GROUP	MODEL
ELE	2024MY EV9 (MV)
NUMBER	DATE
336	April 2024

TECHNICAL SERVICE BULLETIN

SERVICE ACTION: INTEGRATED LED HEADLAMP CONTROL UNIT OPERATION LOGIC IMPROVEMENT (SA567)

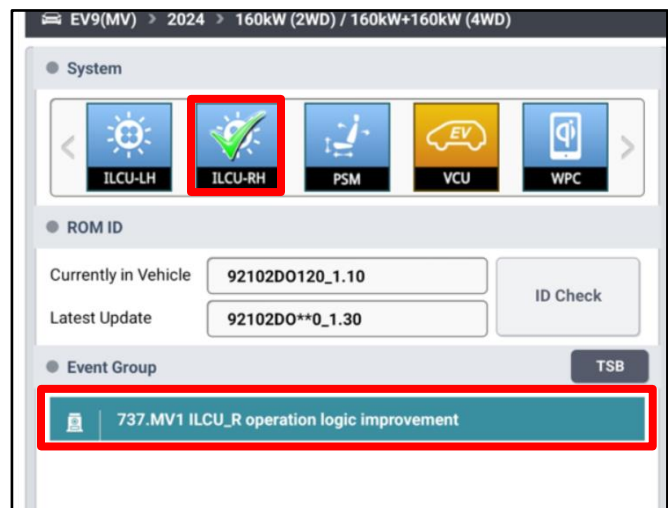
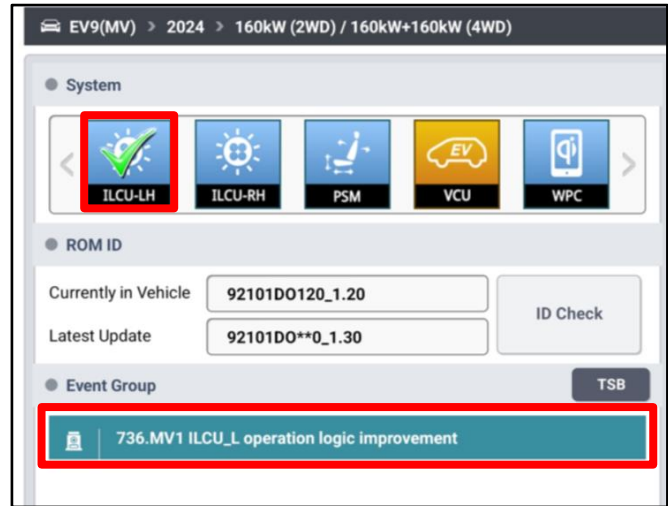
Refer to [TSB SST081](#) for instructions to upgrade the 'ILCU' system:

UPGRADE EVENT:

736.MV1 ILCU_L Operation Logic Improvement

and

737.MV1 ILCU_R Operation Logic Improvement

Both events 736 **and** 737 **MUST** be completed. 'Fault Code Searching' is not required after events 736 and 737 have successfully completed.

The manual upgrade should **ONLY** be performed if the automatic upgrade fails. If the automatic upgrade fails, turn the ignition 'OFF' for about 10 seconds then place it back in the 'ON' position to reset the control unit **BEFORE** performing manual upgrade. See table below for 'Manual Mode' passwords and refer to TSB [SST081](#) for instructions.
